STATE OF CONNECTICUT
CONNECTICUT SITING COUNCIL

DOCKET NO. 395

NEW CINGULAR WIRELESS
RESPONSE TO SITING COUNCIL INTERROGATORIES SET II

Devil's Hopyard North (East Haddam Fish & Game Club Property Site)

SHEET NUMBER
CO2A

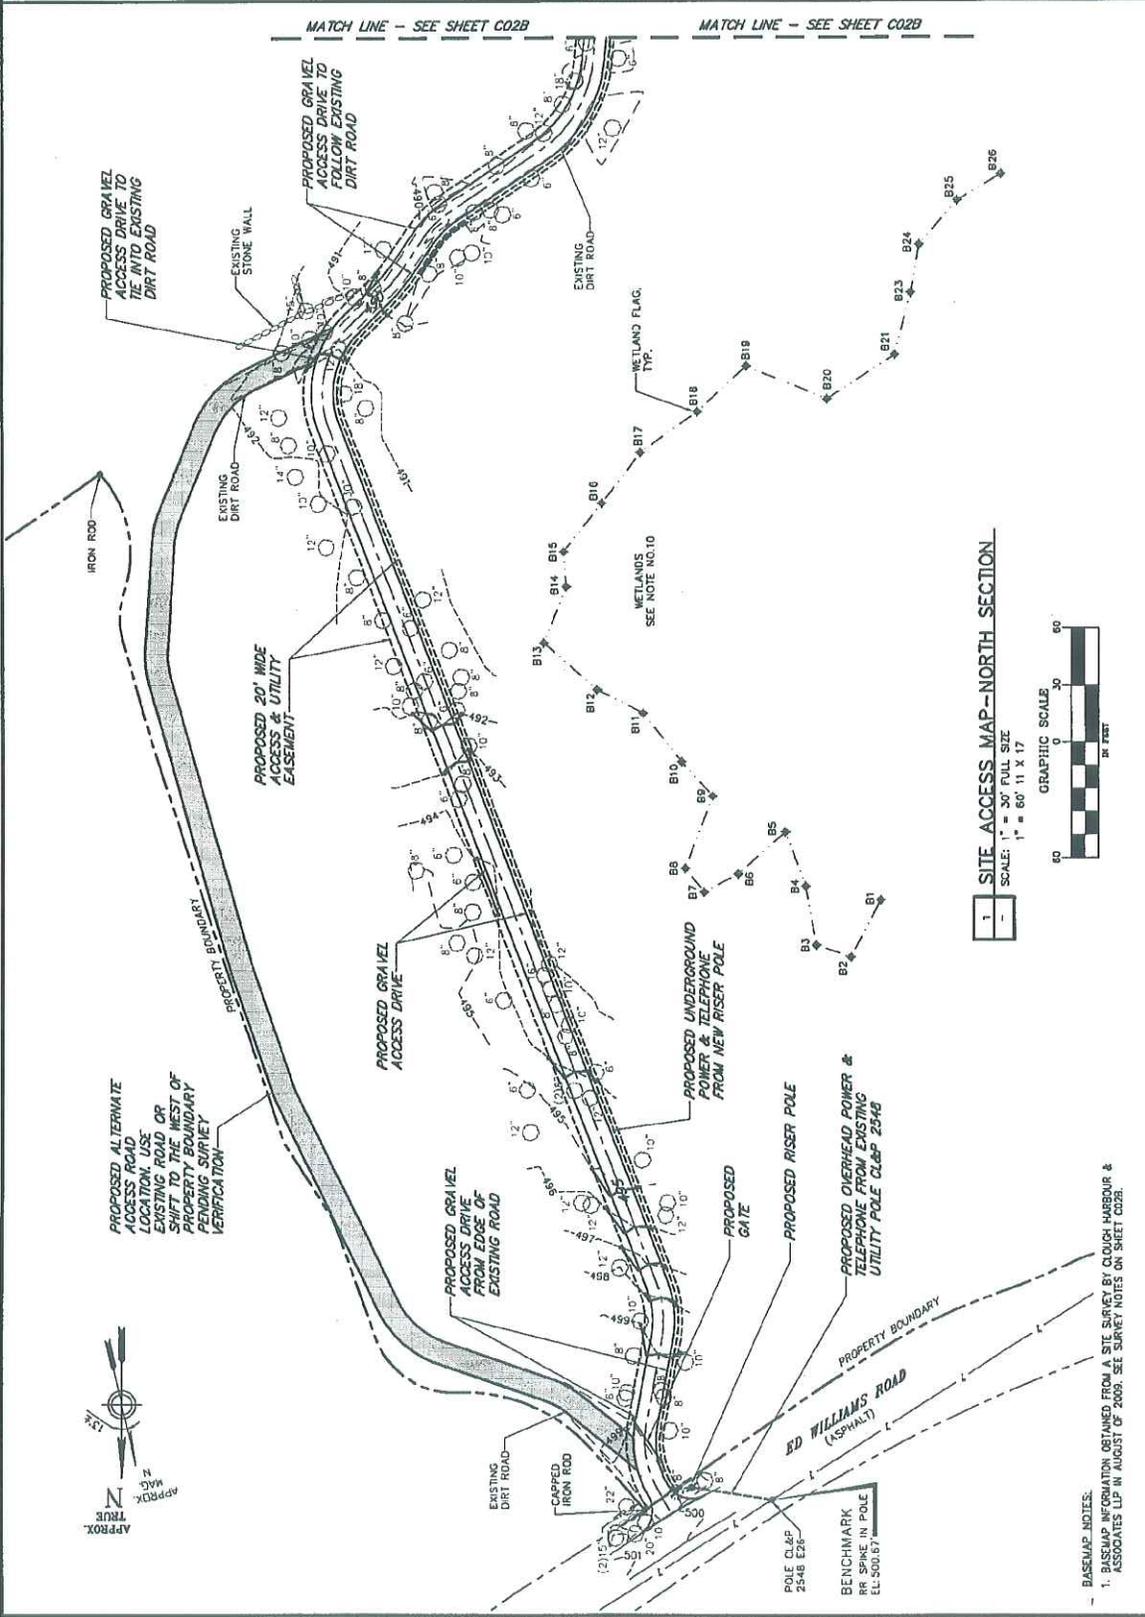
Q12. Describe the advantages and disadvantages to using the existing unimproved woods road as identified on Tab 4/Tab B Map LE-1?

Q12. Describe the advantages and disadvantages to using the existing unimproved woods road as identified on Tab 4/Tab B Map LE-1?

A12. As testified at the public hearing and shown on the drawings, a large portion of the existing unimproved woods road is located on an adjacent parcel and is not benefited by an easement. As such, use of that portion for access and utilities has legal constraints. However, the existing road straddles the property line and as such, AT&T has prepared an alternative access drive for that portion of the facility as shown in the attached drawing in Exhibit B. This alternative access would widen the existing road as needed on the host parcel for access and utilities and have the advantage of less tree removal and further distance from wetlands and potential vernal pools.

Reduced tree clearing, reduced undeveloped land disturbance, and an increased buffer from the adjacent wetlands and potential vernal pools would be the advantages. However, the precise location of the existing road in reference to the property line is unknown. Available preliminary information, such as tax maps and discussions with the land owner, revealed the property is on or partially on the abutting parcel. If this is the case, easements would need to be obtained from the abutting landowner granting AT&T access rights and the utility companies rights across their property. Alternatively, the existing road can be expanded westerly as needed to provide sufficient access on to the subject parcel eliminating the need to obtain an easement from the adjacent land owner. Expanding the road westerly as needed would offer the same benefits of reduced tree clearing, reduced undeveloped land disturbance, and an increased buffer from the adjacent wetlands and suspected vernal pools. A survey for the road expansion would be incorporated into a D&M Plan for this alternate access and utility route.

**Current Coverage plus Proposed Coverage
(s2293 @ 160' and s2292A @ 190')**

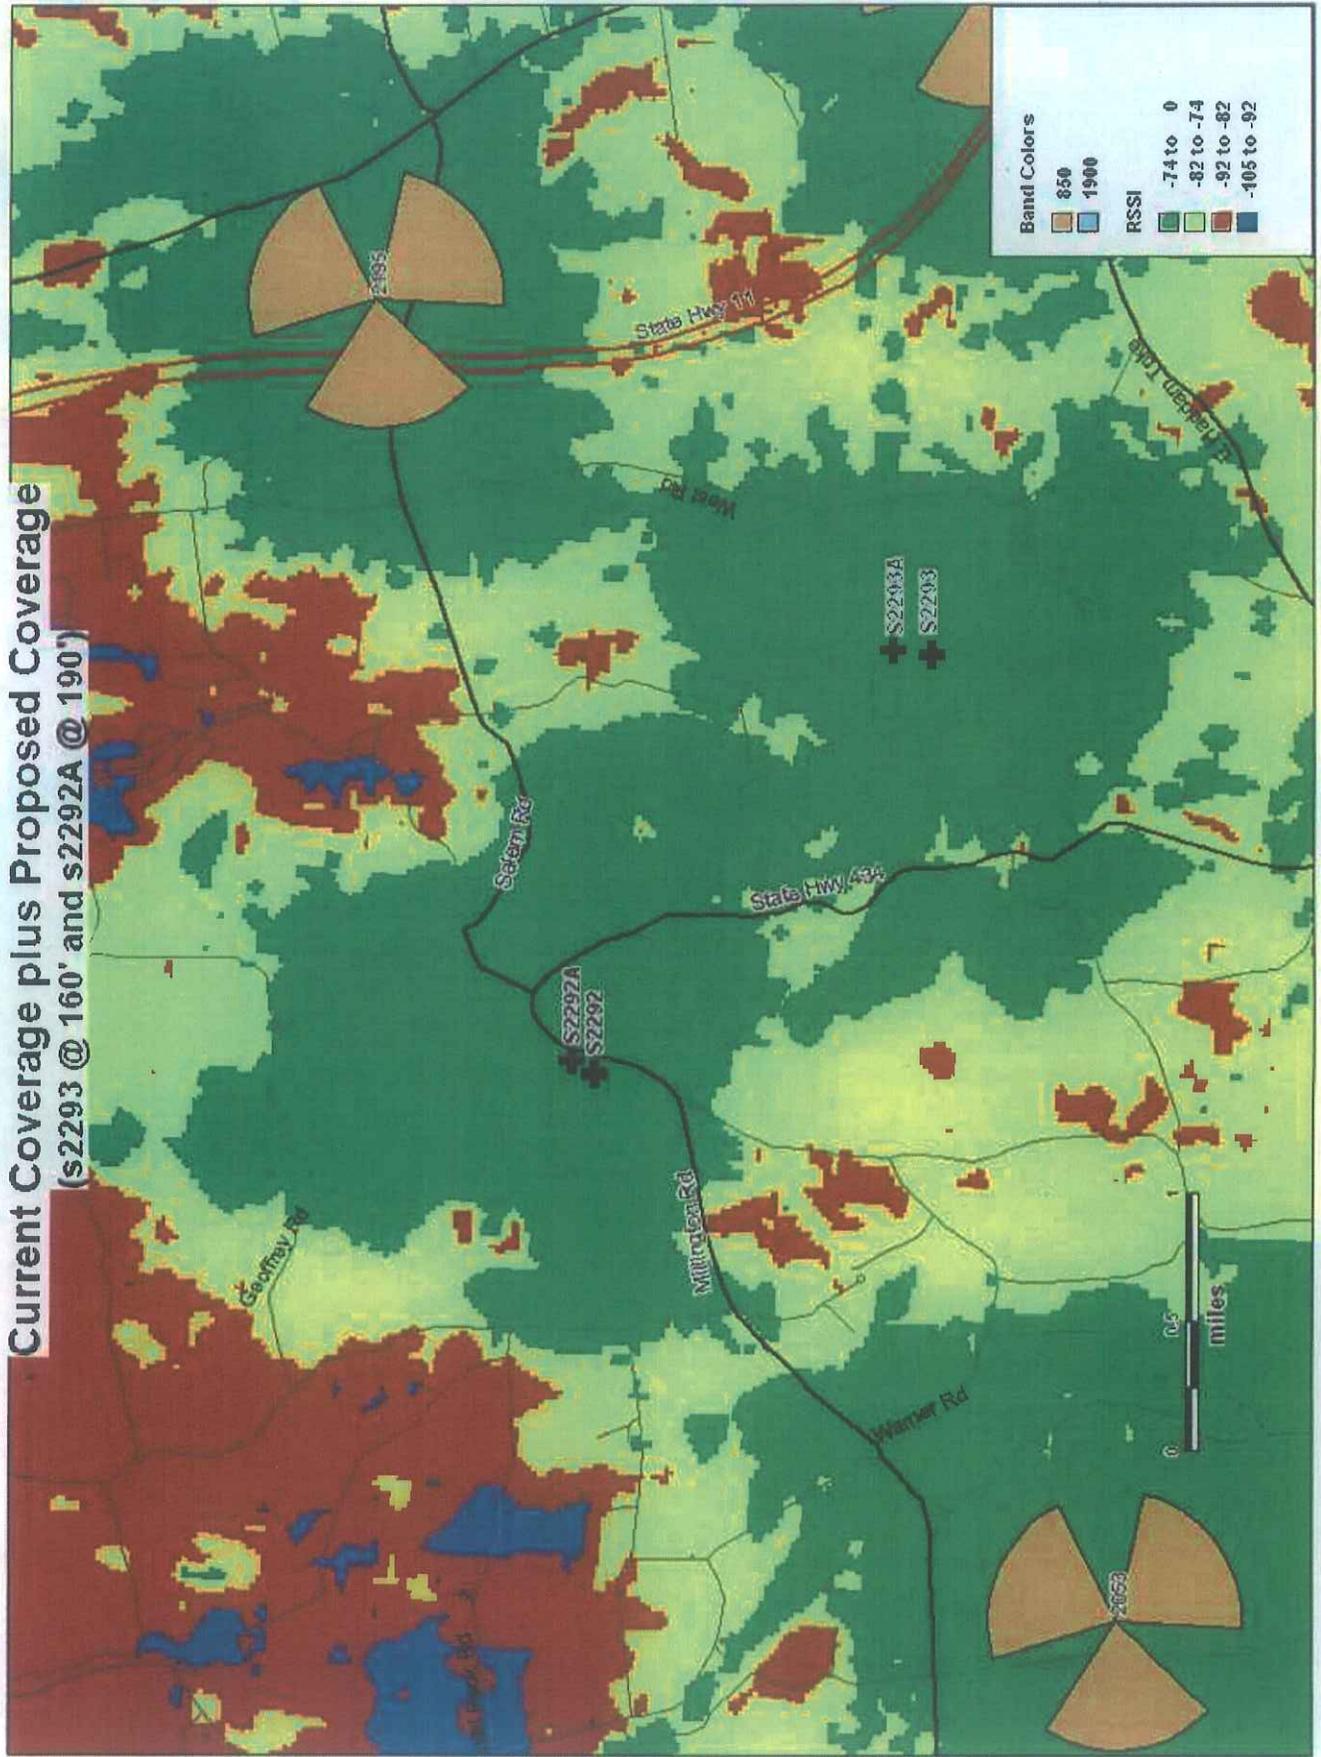
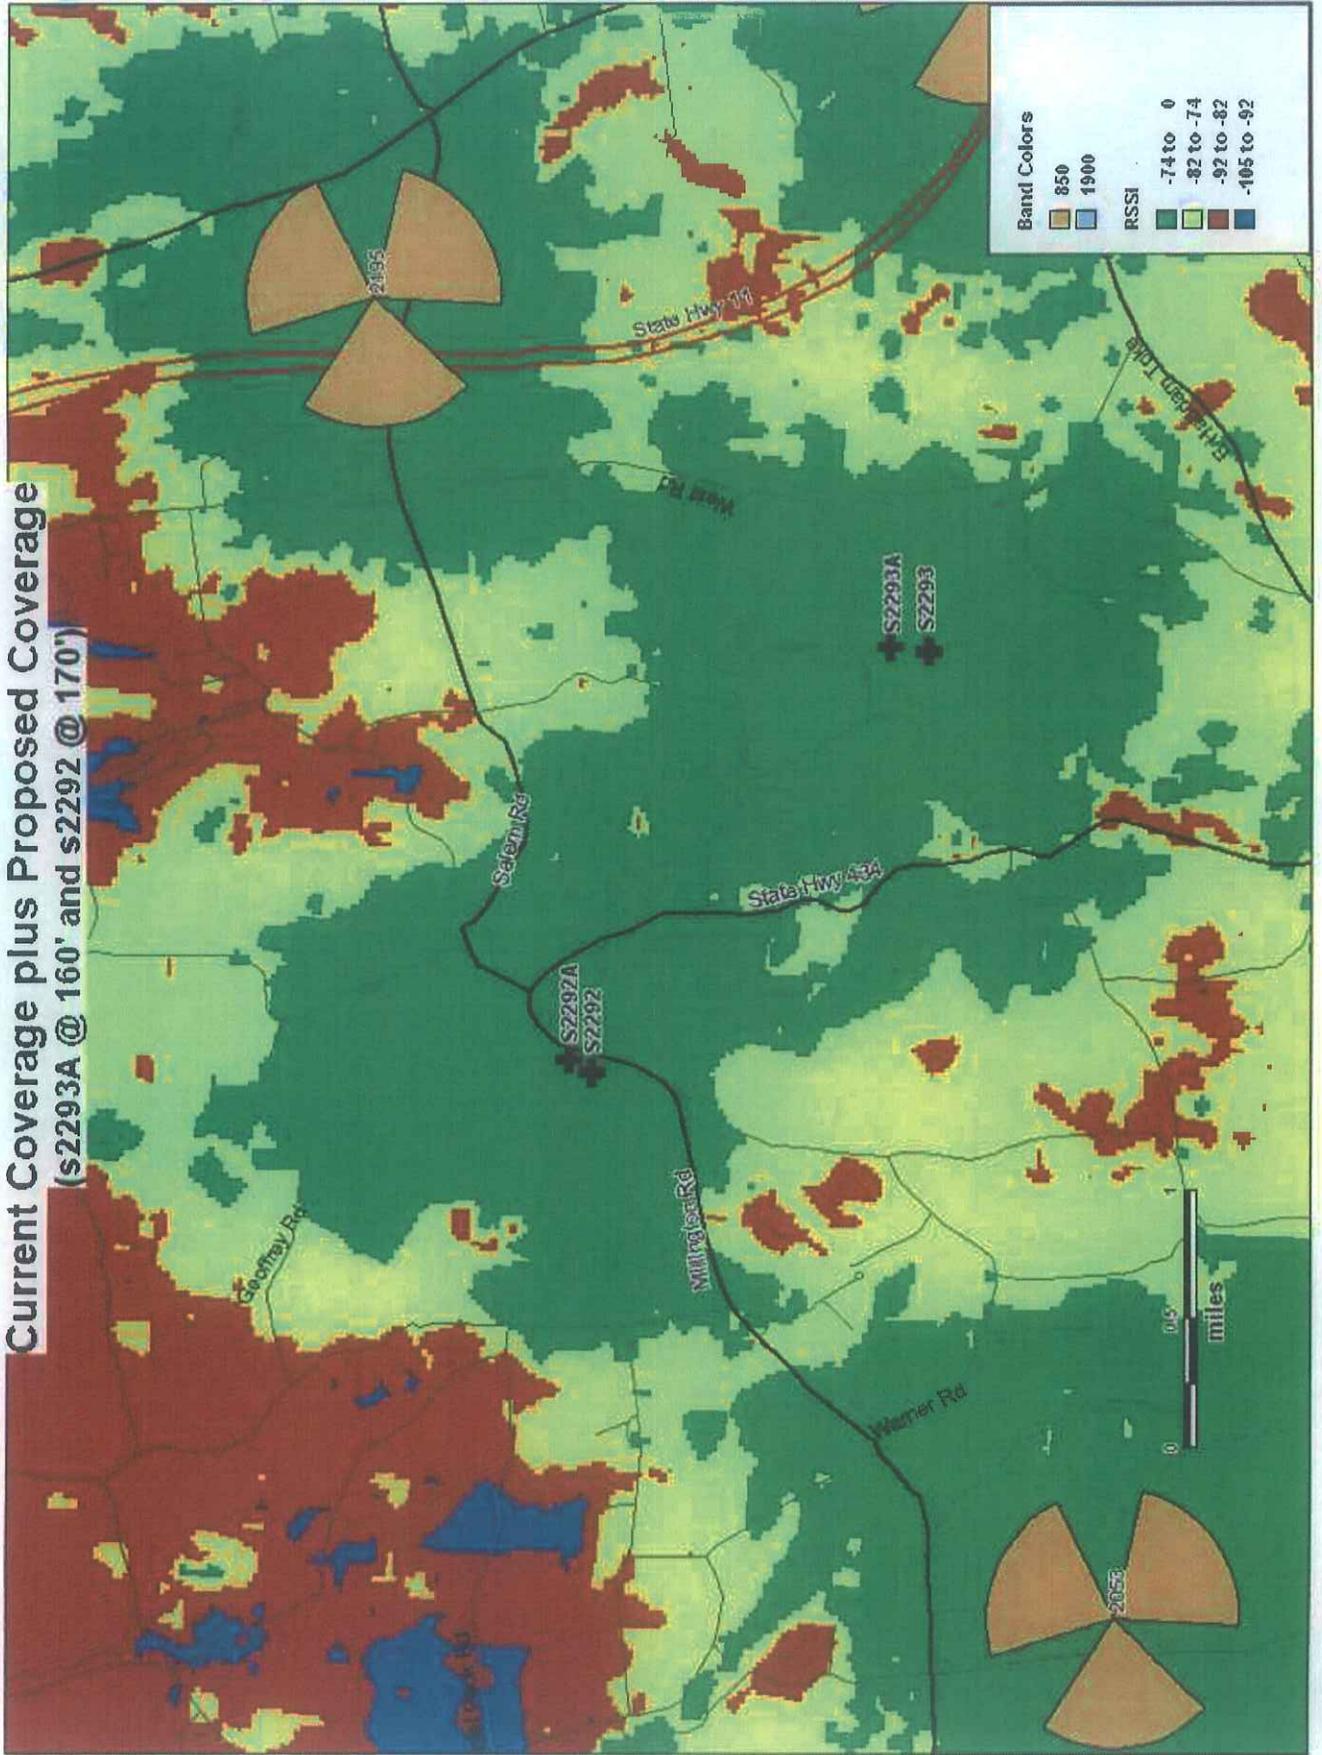
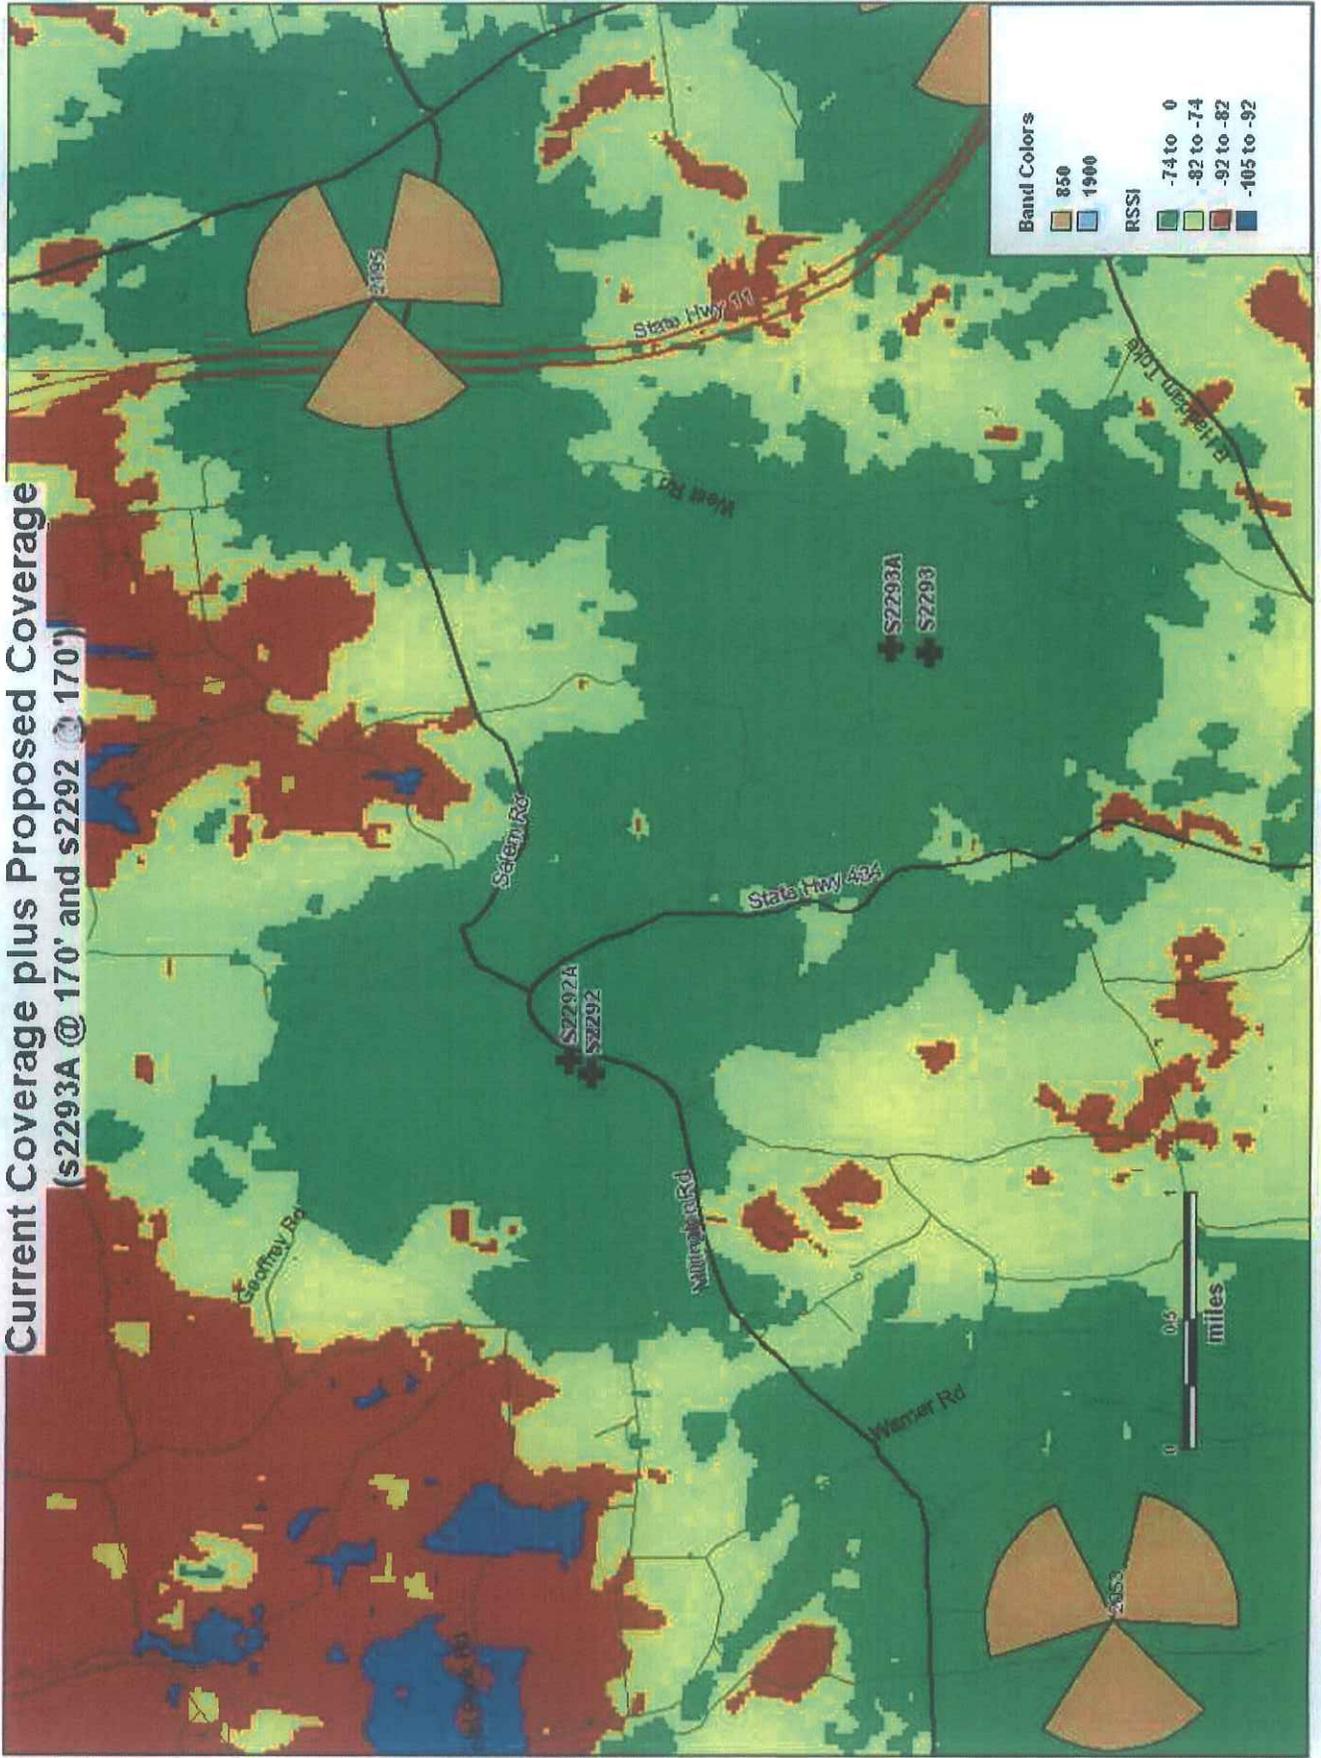
Q26. If the roads are shortened identify the minimum tower height and provide radio frequency propagation plot of the tower for the Devil's Hopyard North site? At the Devils' Hopyard South site?

A26. Neither alternative is as effective as the proposed locations at heights up to 200'. AT&T has determined that the North alternative identified by the Council would need to be a minimum of 198' in height based on terrain. A plot at 190' is included in Exhibit C which shows these relative deficiencies compared to the proposed location. AT&T has determined that the South alternative identified by the Council would need to be at 200' or more in height to provide comparable coverage given localized terrain blocking to the west that is associated with the Devil's Hopyard overlook. This is demonstrated in the progression of plots from 160' through 190' for this alternative which are included in Exhibit C.
